Second Preliminary Consultation
MONTGOMERY COUNTY HISTORIC PRESERVATION COMMISSION
STAFF REPORT

Address:	10221 Menlo Ave., Silver Spring	Meeting Date:	8/14/2024
Resource:	1870-1916 Capitol View Park Historic District	Report Date:	8/7/2024
Applicant:	Kenneth A. Gear	Public Notice:	7/31/2024
Review:	Preliminary Consultation	Staff:	Dan Bruechert
Proposal:	Construction of New Single-Family House Construction

1 EAST ELEVATION
SCALE: 1/4" = 1'-0"

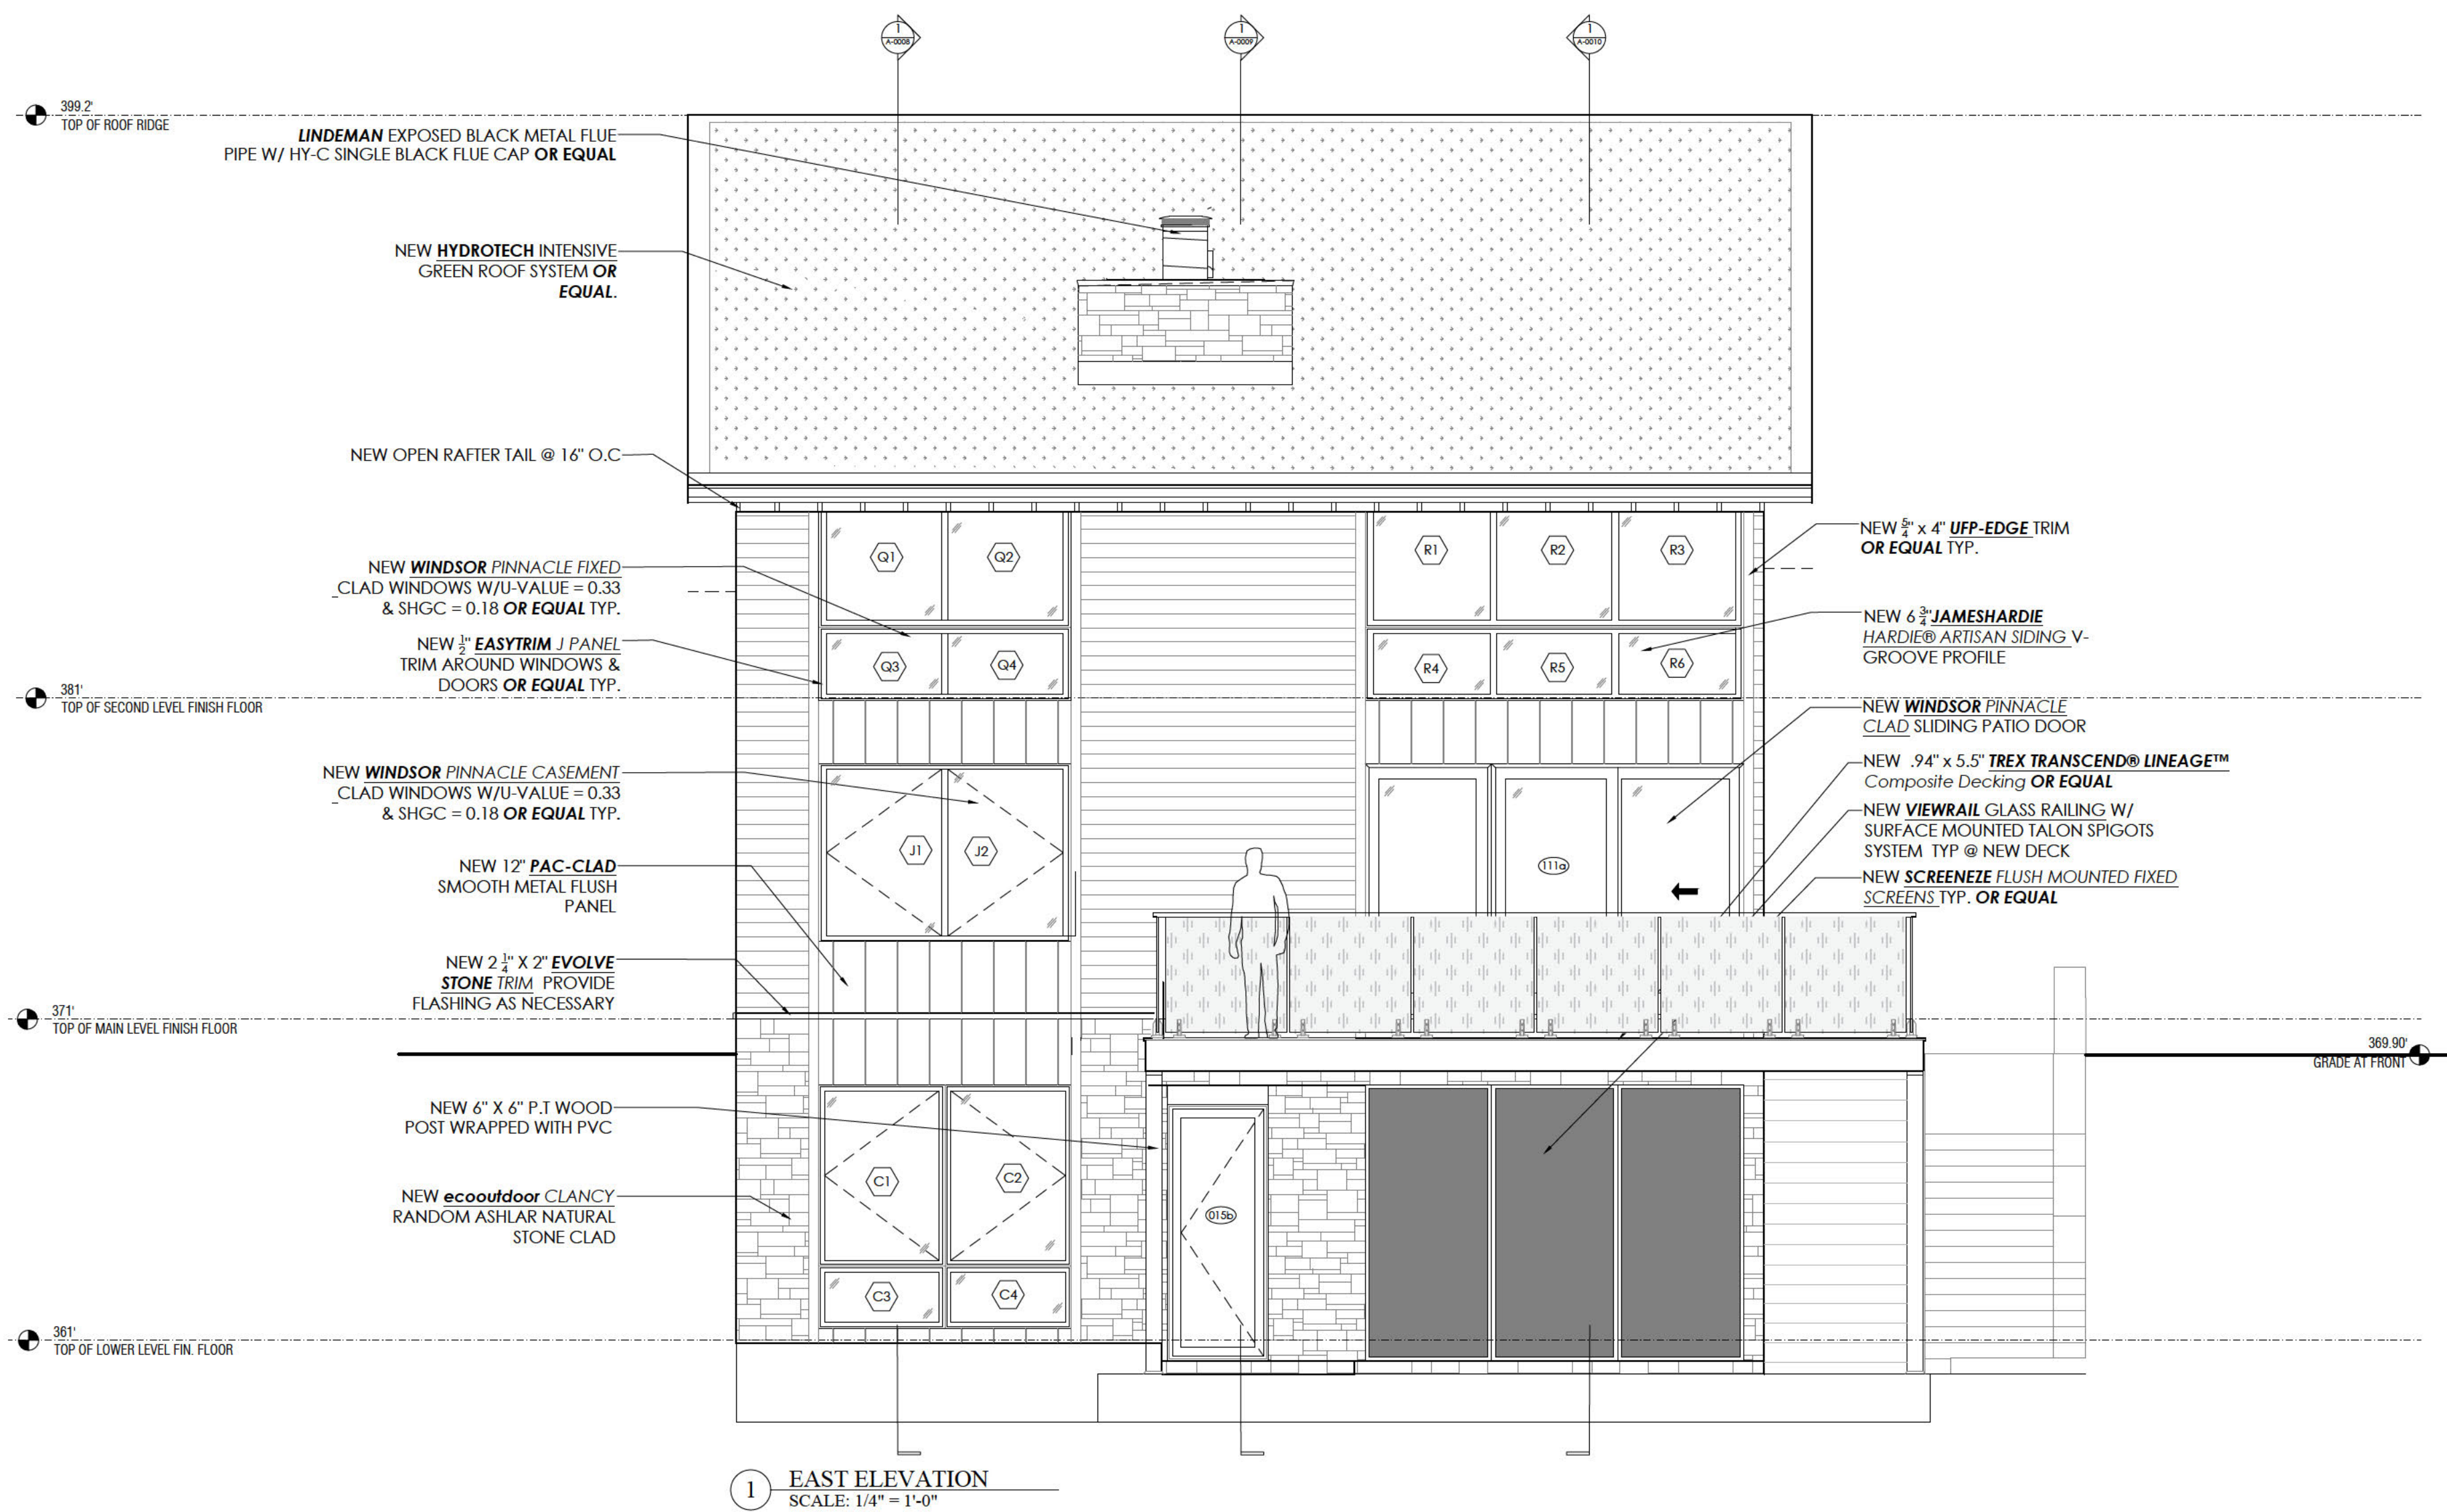
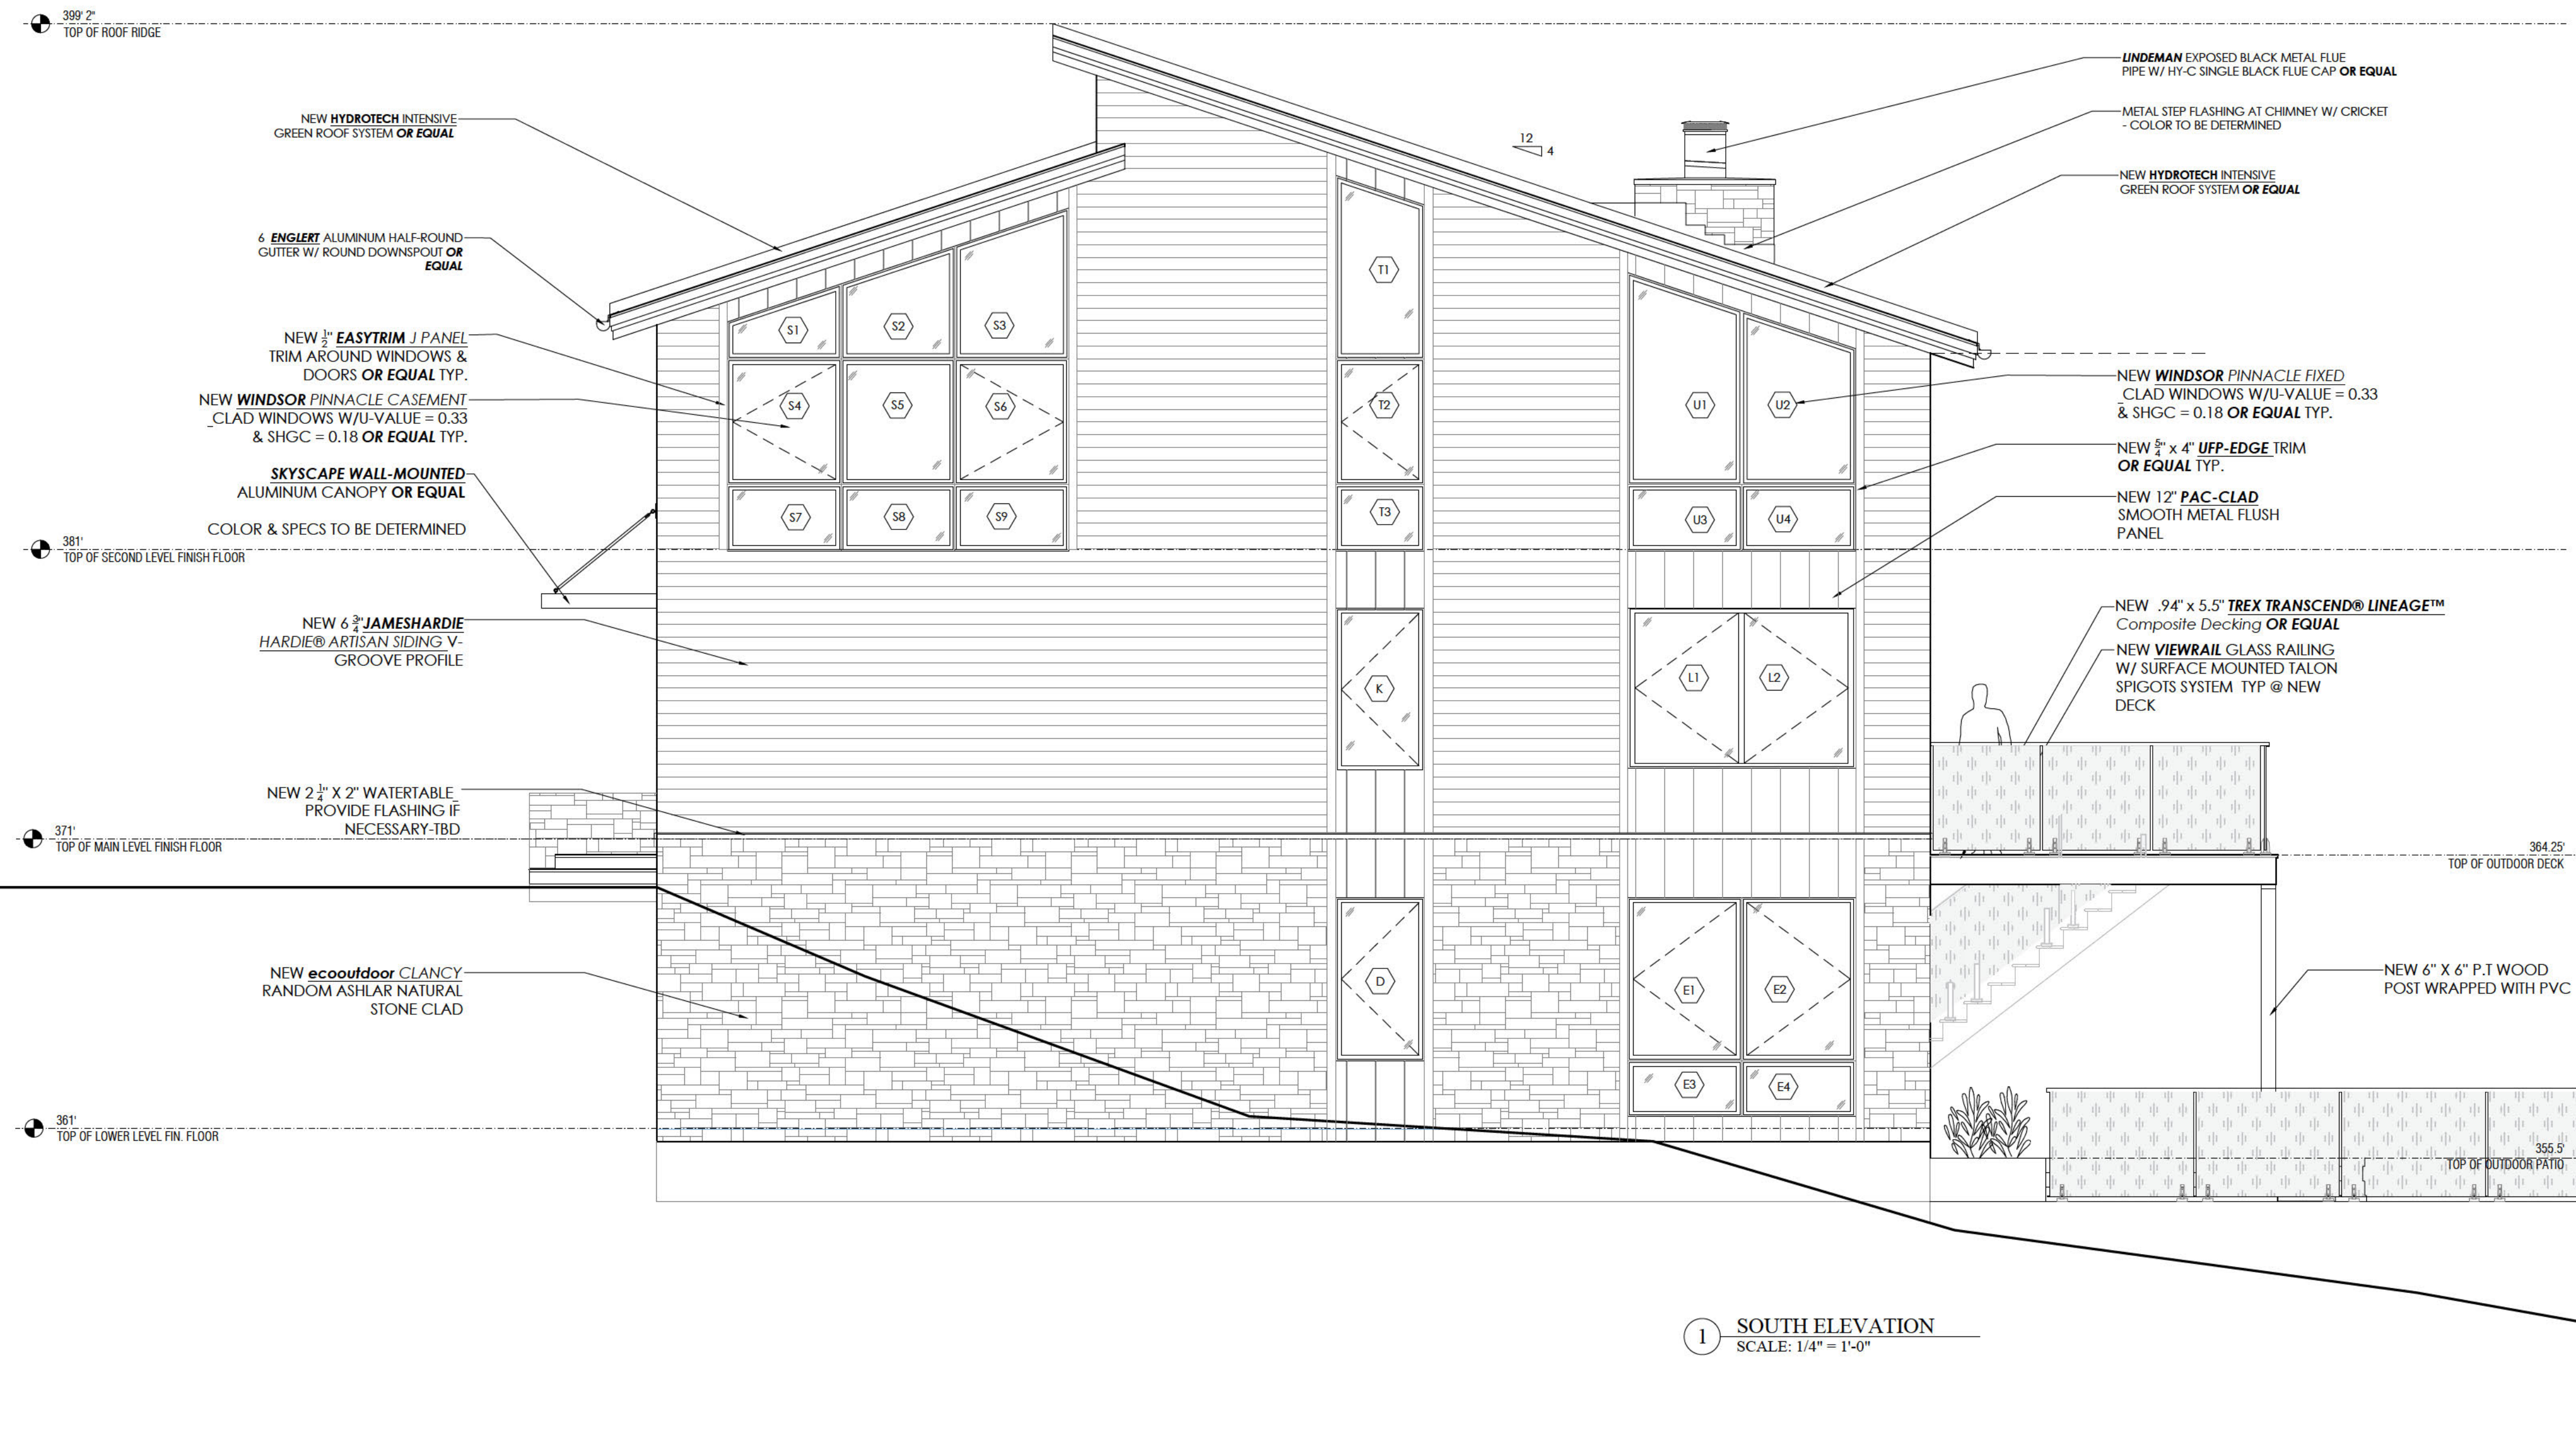
Most of the design elements for the proposed house have been revised from what the HPC reviewed in the January 2024 Preliminary Consultation. The new design includes a monitor roof composed of two shed roof planes. The rear roof plane projects above the lower front roof plane, creating a monitor or clerestory facing west (the front elevation). The house has a central entrance with a one-bay garage on the right. A window, matching the width of the garage door, is proposed to the left of the front door. Second-floor windows are proposed over the first-floor openings. Over the front door, the applicant proposes to install a 'Kalwall' translucent window panel, that bisects the front roof plane. The house will be covered in fiber cement siding, with selections of PAC-CLAD metal panels. The applicant proposes to install a green roof on both roof planes. The rear elevation of the house is mostly glazed, with a rear deck. Below the deck, there is a walk-out patio. The patio appears to be approximately 35' (thirty-five

feet) deep, narrowing to approximately 15' (fifteen feet). No material is identified for the proposed patio.
